SUBDIVISION REVIEW SHEET**CASE NO.:** C8J-2021-0048.1A**ZAP DATE:** December 6, 2022**SUBDIVISION NAME:** Quad Park 3B-3a Final Plat**AREA:** 26.52 acres**LOT(S):** 63**OWNER/APPLICANT:** Carma Easton , LLC
(Matthew McCafferty)**AGENT:** Carlson, Brigrance, and Doering, Inc
(Brett Pasquarella)**ADDRESS OF SUBDIVISION:** Apogee and Skytex**GRIDS:** K11**COUNTY:** Travis**WATERSHED:** N. Fork & S. Fork Dry Creek**JURISDICTION:** Limited Purpose**EXISTING ZONING:** Planned Unit Development (PUD)**MUD PLAN:** Pilot Knob MUD**PROPOSED LAND USE:** Mixed Residential, greenbelt/open space/drainage easement lots, and public ROW**VARIANCES:** None**SIDEWALKS:** Sidewalks will be provided along all internal streets and the boundary street.

QUAD PARK 3B-3a

**CITY OF AUSTIN – TRAVIS COUNTY – SINGLE SUBDIVISION OFFICE
SUBDIVISION APPLICATION – MASTER COMMENT REPORT**

PROJECT NAME: Quad Park 3B-3a Final Plat
LOCATION: 8408 APOGEE BLVD

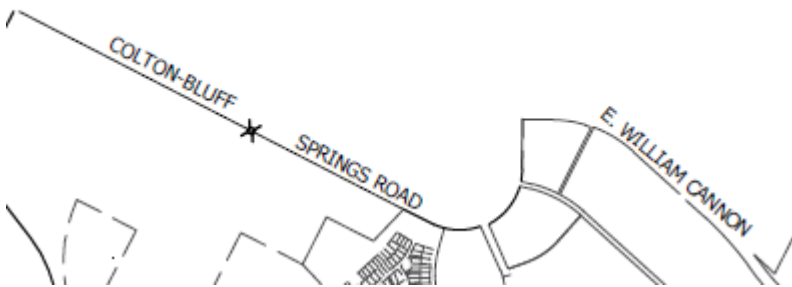
AD1: This plat review is rejected for the following:

AD2: Please remove the punctuation marks on all streets in the locator map

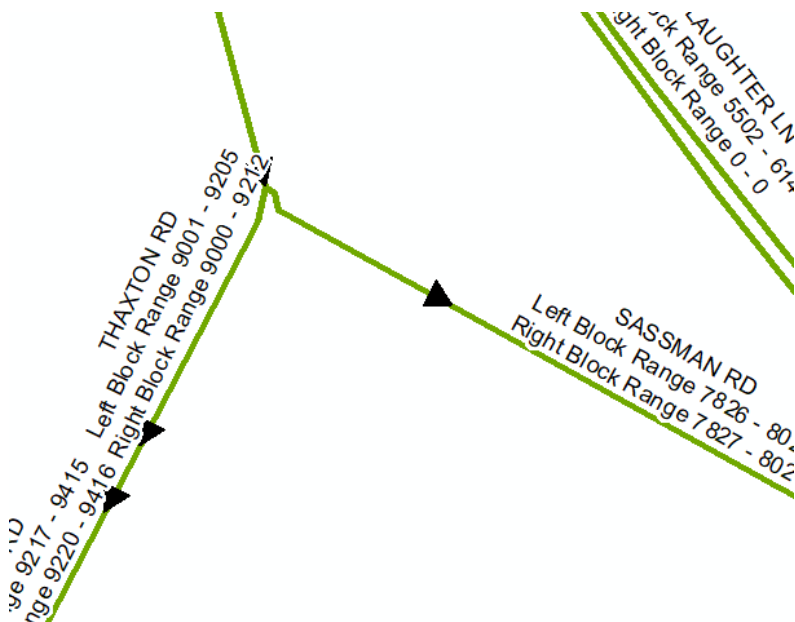
AD3: Please update label for **SASSMAN RD** the street type RD must be included

AD4: Please update label for **THAXTON RD** the street type RD must be included

AD5: **DONGAN DR** is the correct street name for this project

NOTE: DONGAN DR is incorrectly labeled as DONGAN OAK CRT on all sheets. OAK is on the DO NOT USE list and is an overused word. Court is also a street type designated by a cul-da-sac which this is not.
